**Report to Committee**

**To:** Planning Committee **Date:** March 30, 2007  
**From:** Jean Lamontagne **File:** RZ 04-287969  
Director of Development  
**Re:** **Application by Matthew Cheng Architect for Rezoning at 8411 and 8391 Williams Road from Single-Family Housing District, Subdivision Area E (R1/E) to Townhouse District (R2 - 0.7)**

Re: **Response to City Review of Arborists Report**

**TREE RETENTION PLAN**

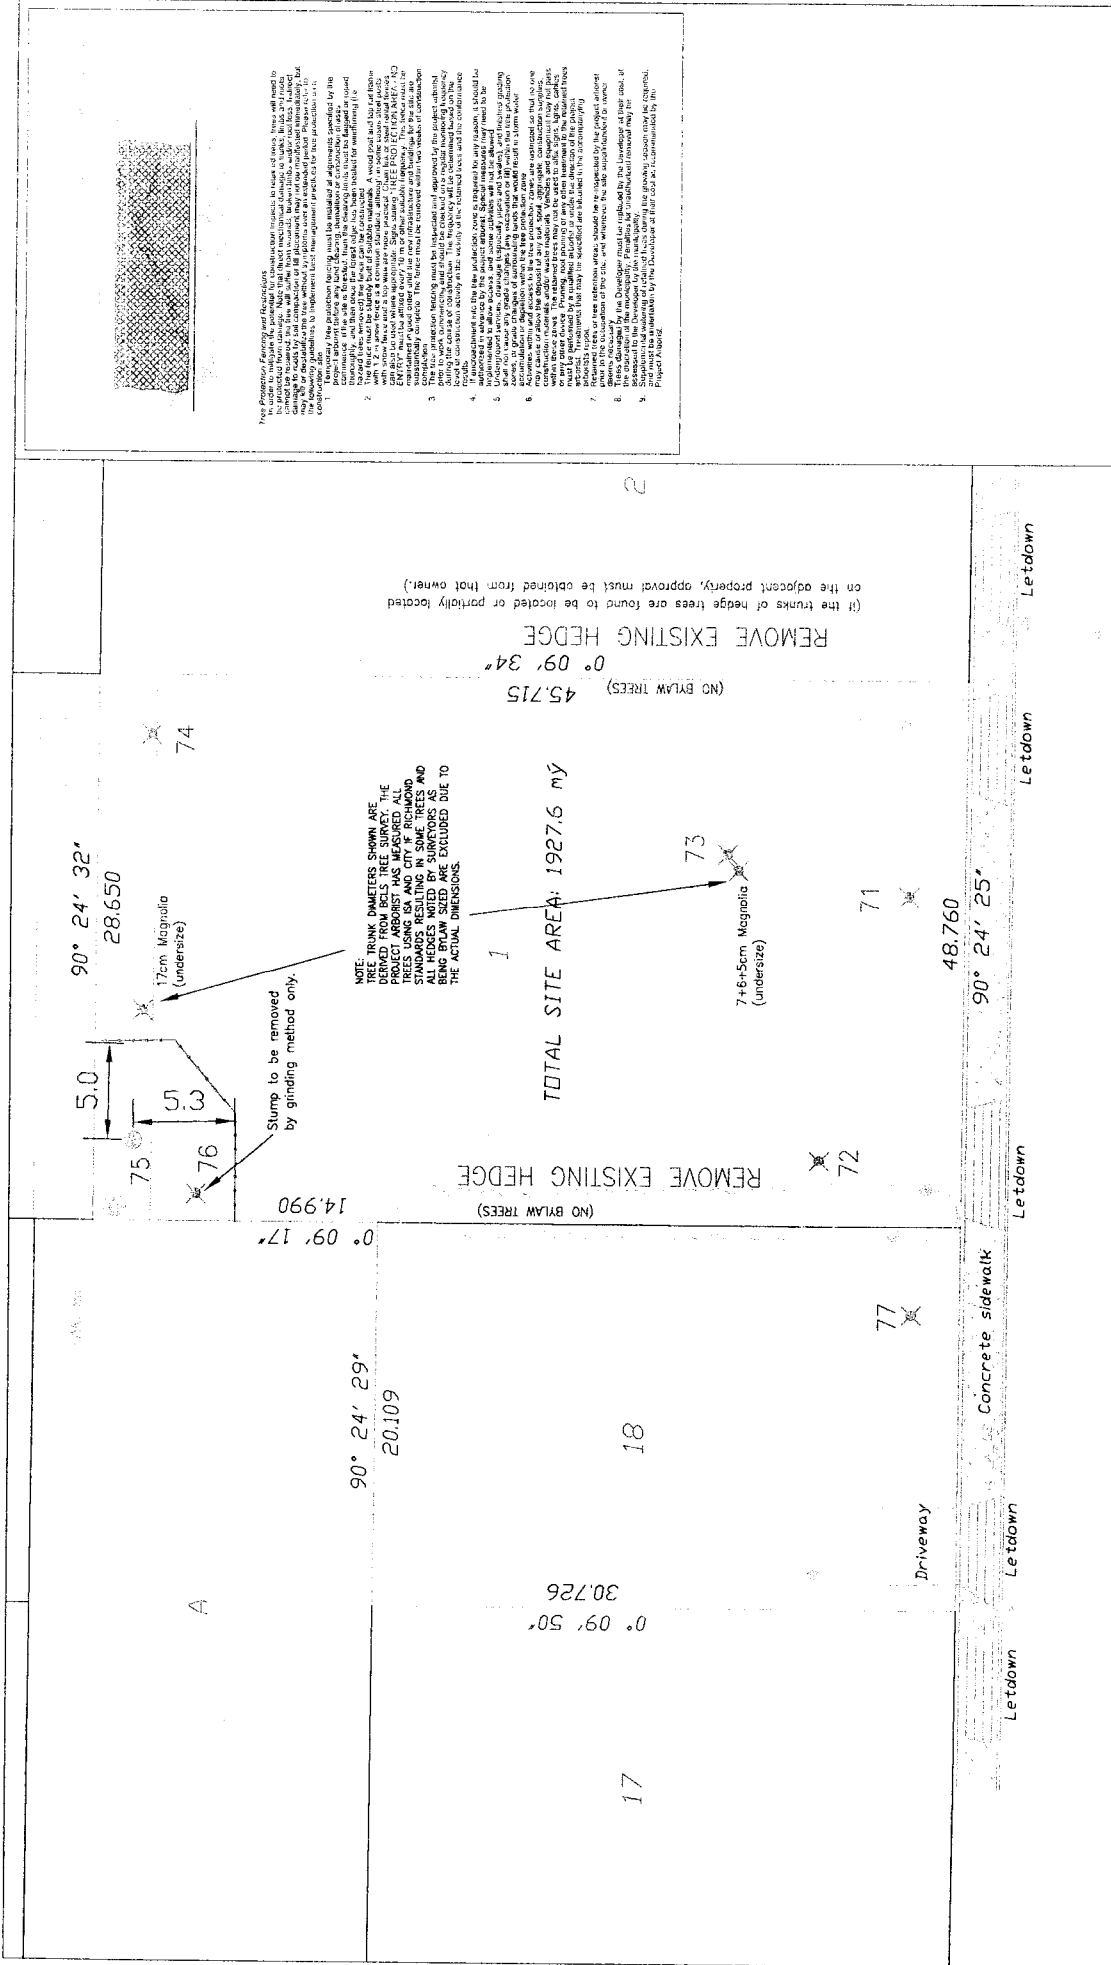
- The hedge on the west side is now specified for removal. Indeed, this hedge is on poor condition. A note indicating the need for adjacent owners' approval if the trunks are located on the adjacent property. Based on the survey, the trunks of the hedge trees appear to be wholly located on the subject site, however the property line should be staked accurately before proceeding.

- Two undersized trees were marked on the tree survey with the incorrect trunk diameters. We had measured them and identified the species in our previous site visits, and recently added them to the plan as requested.

- The tree #75 that is proposed to be retained has a dripline radius of 5.0m. The tree protection fence is aligned to coincide with the dripline, meeting the city requirements. I have added dimensions to the plan for clarity.

- The stump for tree # 76 must be removed by low impact method. In order to protect the roots of the adjacent retained tree, I have specified that stump grinder should be used, as noted on the revised plan.
